Access Compliance Report

Public Rights-of-Way

(Curb Ramps)

Intersection ID: 51011	Main Street: TREMONT_PLACE_RD	Cross Street: BENDING_BRANCH_RD	Location:	N
ADA ID: 42026600B573	Ramp Type: Perp	Initial Pass/Fail: Fail	Overall Compliance: No	Severity Score: 21.25
Codes/Mitigation Info/Possible Solution		Field Measurements/Component Compliance

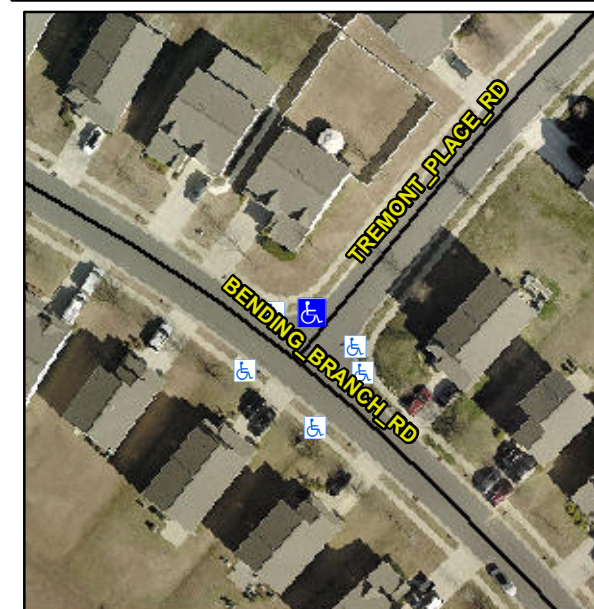
Not Found, R304.5.1, R304.2.2

Compliance	Description	Data	Compliance	Description	Data
N/A	Ramp Length (in)	48.5	No	Ramp Slope (%)	10.7
No	Ramp Width (in)	47.0	Yes	Ramp XSlope (%)	0.0
N/A	Flare Type LT	N/A	N/A	Flare Type RT	N/A
N/A	Flare Slope LT (%)	N/A	N/A	Flare Slope RT (%)	N/A
N/A	Flare Traversable LT?	N/A	N/A	Flare Traversable RT?	N/A
N/A	Landing Length (in)	N/A	N/A	DWS Provided?	N/A
N/A	Landing Width (in)	N/A	N/A	DWS Contrast?	N/A
N/A	Landing Slope (%)	N/A	N/A	DWS Length (in)	N/A
N/A	Landing X Slope (%)	N/A	N/A	DWS Full Width?	N/A
N/A	Landing Curb? (Y/N)	N/A	N/A	DWS Offset (in)	N/A
N/A	Shared Landing?	N/A			
N/A	Gutter Ponding?	N/A	N/A	Gutter Slope (%)	N/A
N/A	Gutter Lip Ht (in)	N/A	N/A	Gutter X Slope (%)	N/A
N/A	Painted X Walk1?	No	N/A	Painted X Walk2?	N/A
	X Walk 1 Direction	To SW		X Walk 2 Direction	N/A
N/A	X Walk 1 Width (in)	N/A	N/A	X Walk 2 Width (in)	N/A
	X Walk 1 Slope (%)	3.5		X Walk 2 Slope (%)	N/A
	X Walk 1 X Slope (%)	2.6		X Walk 2 X Slope (%)	N/A

Remove & Replace Entire Ramp.
